## Addendum

Iowa Department of Transportation Office of Contracts Date of Letting: September 17, 2013 Date of Addendum: August 30, 2013

<b>B.O.</b>	Proposal ID	Proposal Work Type	County	Project Number	Addendum		
101	55-1698-059	PCC OVERLAY - UNBONDED	KOSSUTH	NHSX-169-8(59)3H-55	17SEP101.A01

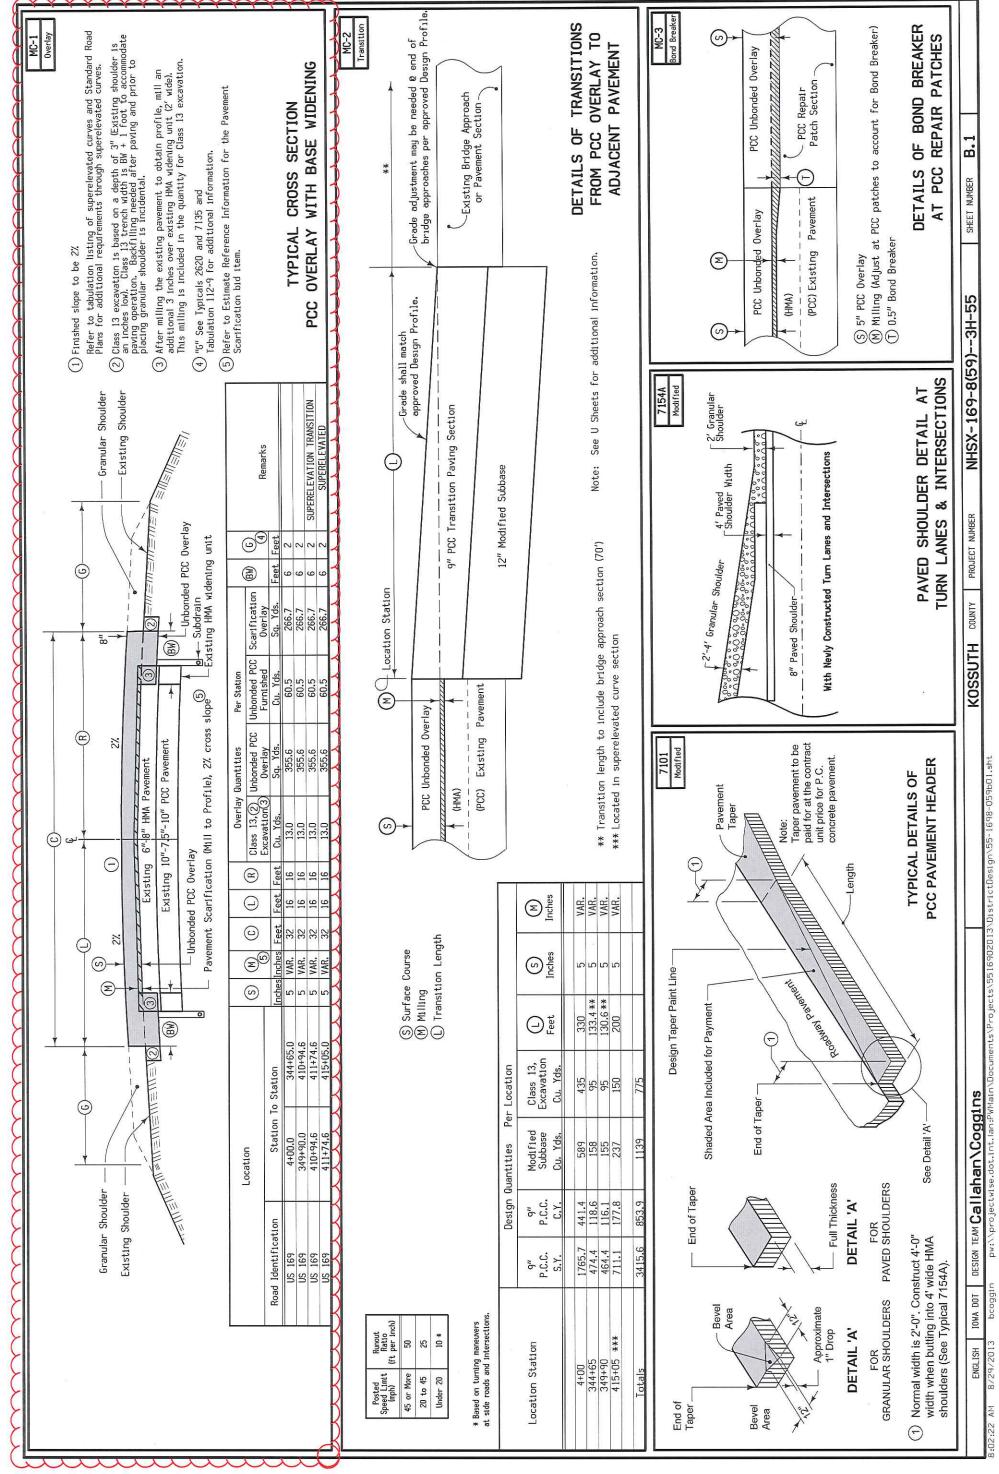
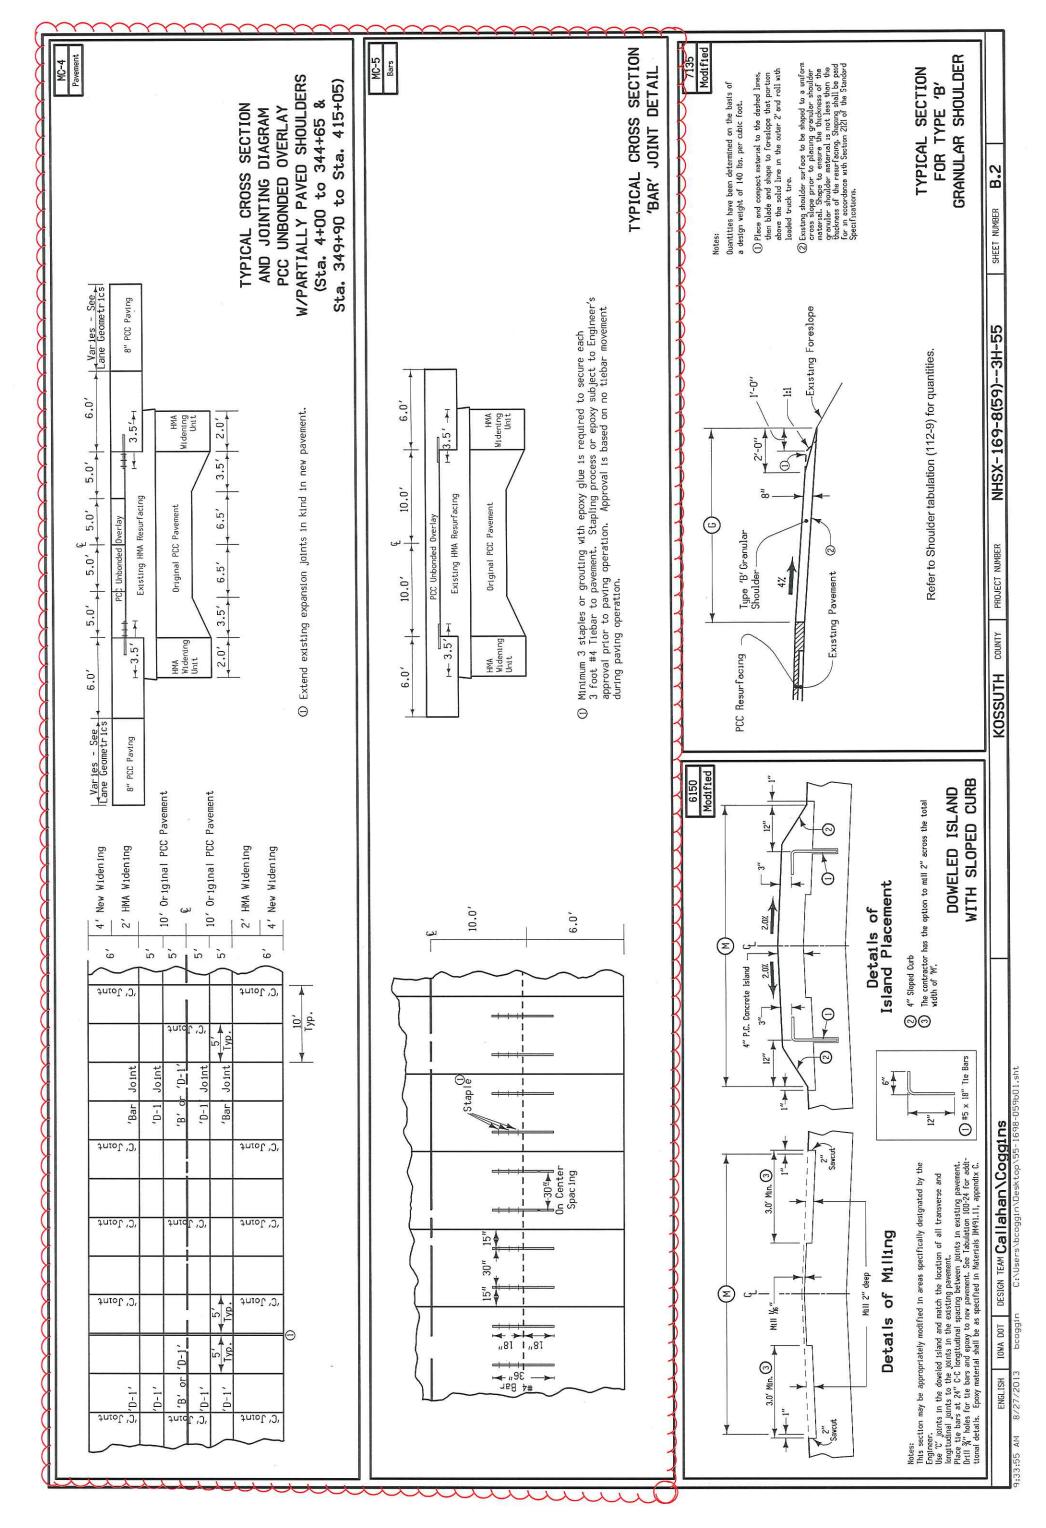
Make the following changes to the PROPOSAL SCHEDULE OF PRICES:

Change Proposal Line No. 0110 2213-2713300 EXCAVATION, CLASS 13, FOR WIDENING: From: 4,741.000 CY To: 6,242.000 CY

Change Proposal Line No. 0230 2310-5151600 PORTLAND CEMENT CONCRETE OVERLAY, QM-C, FURNISH ONLY: From: 23,049.000 CY To: 24,550.000 CY

If the above changes are not made, they will be made as shown here.
